Re: Request for Additional Information – Mixed-use development with affordable housing at 57-61 Archer Street and 34 Albert Avenue, Chatswood (SSD-72891212)

This letter has been prepared by Mecone on behalf of Chatswood Property Pty Ltd c/o Coronation Property Co. Pty Ltd. (Coronation) (the **applicant**) in relation to the State Significant Development Application (**SSDA**) SSD-72891212 at 57-61 Archer Street and 34 Albert Avenue, Chatswood (the **site**).

Figure 1: Options Analysis for Substation Location

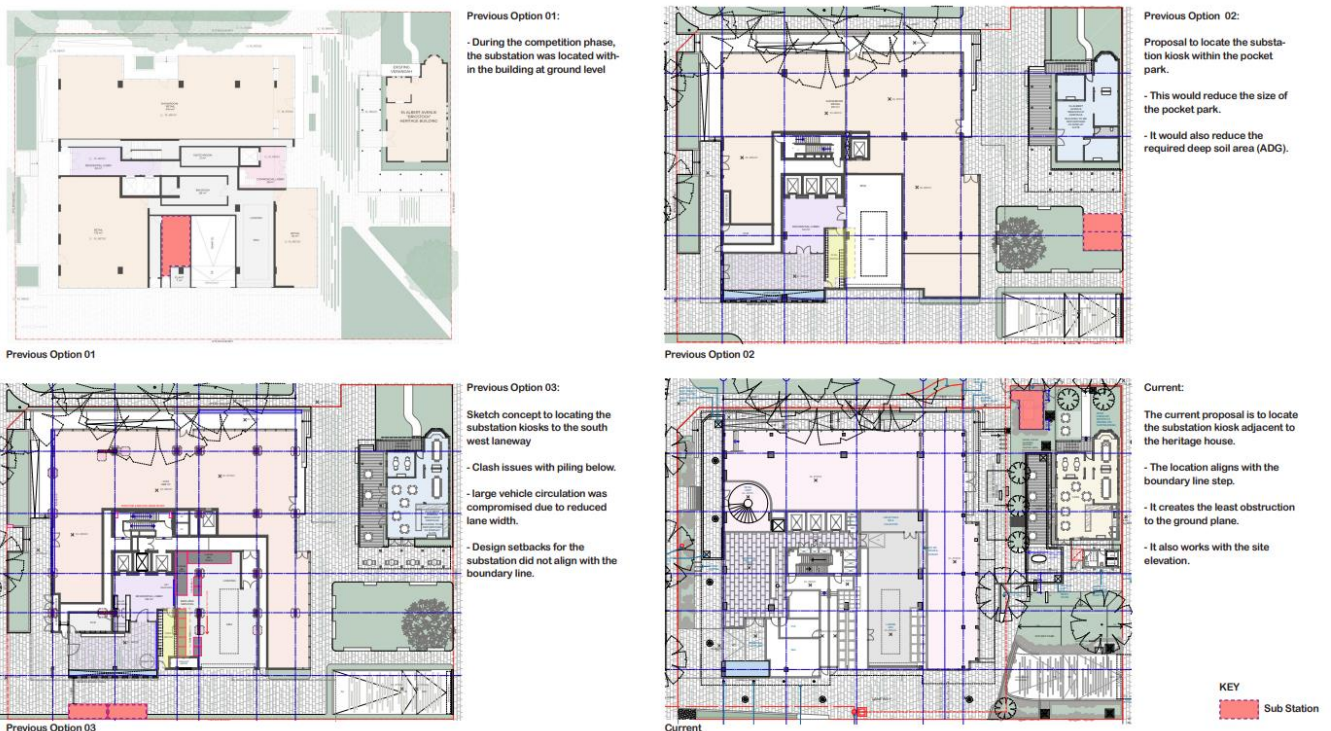
Issue 3: The Department notes that the RtS outlines that the substation is required in the proposed location to meet Ausgrid requirements. As requested in the Department’s previous letter dated 20 February 2025, provide further analysis of alternative substation locations, which have/can be considered. This should also include details and justification for locations which are not feasible, to support the substation location.

Despite this and in response to the Department’s request, an options analysis was undertaken in collaboration with the project architects, and the outcomes are summarised in the annotated plans at **Attachment H** and **Figure 1**. Four potential substation locations (including the current location) were explored outlined in the image and table below.

Options	Analysis
<i>Option 01 – Within the building at ground level</i>	During the competitive design process, the substation was initially shown within the building footprint at ground level. This option would require the loss of valuable commercial floor space, lobby areas, and/or the loading dock, thereby reducing the efficiency, activation, and functionality of the building. It would also compromise site planning principles established through the endorsed design competition scheme.
<i>Previous Option 02 – Within the pocket park</i>	Consideration was given to locating the substation kiosk within the pocket park adjoining the site. However, this option would diminish the size and usability of the park and reduce the required deep soil area under the Apartment Design Guide (ADG). It would also conflict with key urban design outcomes and compromise the delivery of high-quality public open space envisaged as part of the project.

<i>Option 03 – South-west laneway</i>	Consideration of placing the substation within the south-western laneway. This location was found to have significant clash issues with piling below and would have compromised large vehicle circulation due to reduced lane width. In addition, this location required design setbacks for the substation which would not align with the boundary line step, resulting in inefficient use of space and conflicts with Ausgrid’s servicing requirements.
<i>Option 04 – Adjacent to heritage building (within existing hardstand area)</i>	The current proposal is to site the substation adjacent to the heritage house, within the existing hardstand parking area at the front of the site. This location aligns with the property boundary, avoids obstruction of the main ground plane, and integrates with the natural site elevation. Importantly, it represents the least obstructive option while ensuring compliance with Ausgrid’s technical and servicing requirements.

Based on the detailed options analysis and as illustrated in the attached plans, the current location of the substation represents the optimal balance between technical feasibility, heritage protection, visual integration, and urban design objectives. Other locations considered would result in unacceptable impacts on building functionality, public open space, servicing arrangements, or heritage outcomes.
